R44 SERVICE BULLETIN SB-120

SUBJECT: Clutch Assembly Magnetic Plug Retrofit and Inspection

EFFECTIVITY: C018-2, -3, -4, and -5 clutch assemblies without factory-installed B569-1 magnetic plugs are affected by this bulletin. Factory-installed B569-1 magnetic plugs began production in October 2026 and have a dot of orange paint applied to head; see Reference Image on page 5.

Figure 1: B289-3 Screw Location in C168-5 Retainer

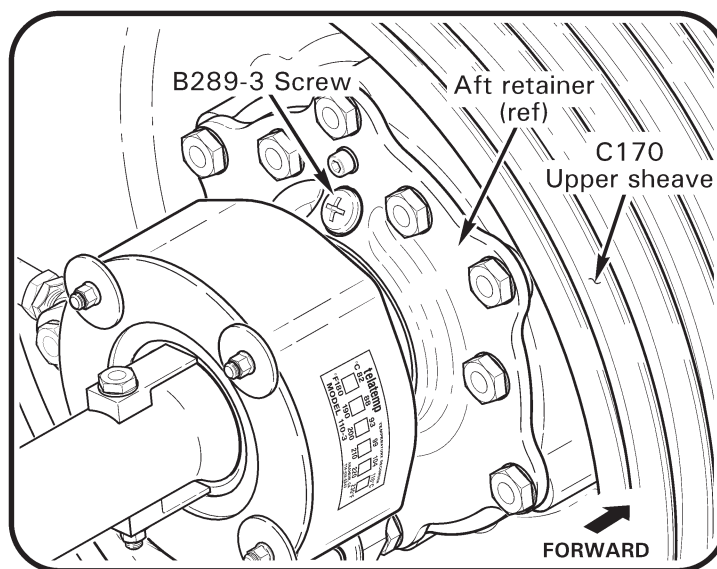
3. Refer to Figure 1. Rotate upper sheave by hand to locate B289-3 screw in both forward and aft retainers. If either screw is not present, then clutch assembly must be removed from service.

4. Rotate upper sheave until forward retainer's B289-3 screw is at highest position. Remove screw. Install B569-1 magnetic plug (#3 Phillips) and torque to 50 inch-pounds.

5. Rotate upper sheave until aft retainer's B289-3 screw is at highest position. Remove screw. If fluid level is not visible, top off fluid with A257-4 lubricant. Install B569-1 magnetic plug and torque to 50 inch-pounds.

Figure 2: B569-1 Magnetic Plug Debris Measurement

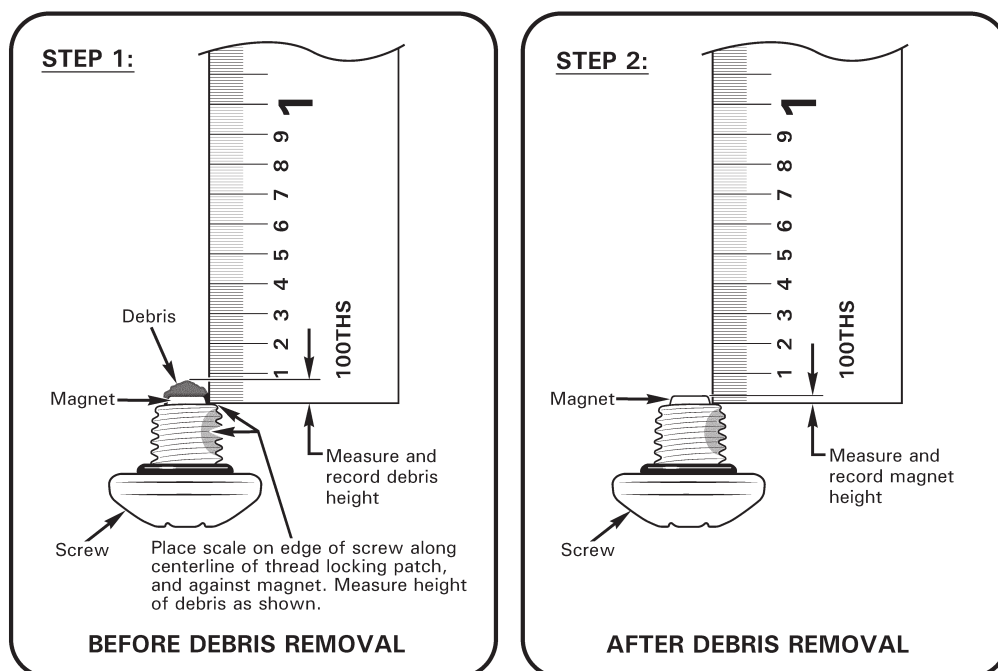
5. Measure and record combined debris and magnet height using a 0.01 inch resolution scale per Figure 2 Step 1.
6. Use a clean, lint-free cloth to collect all debris from magnetic plug; set cloth aside for later inspection.
7. Measure and record magnet height using a 0.01 inch resolution scale per Figure 2 Step 2.
8. Calculate debris height by subtracting magnet height from total height of magnet with debris. Debris height = [(step 5 measurement) – (step 7 measurement)]. Record result.

9. If calculated debris height is less than or equal to 0.02 inch, proceed to step 10. If calculated debris height exceeds 0.02 inch, record failed inspection result.

10. Visually inspect debris on cloth(s) collected in step 6. Debris may be black flake(s), chip(s), small particle accumulation, and/or thin metallic slivers. If any piece of debris exceeds 0.050 inch in any direction, record failed inspection result.
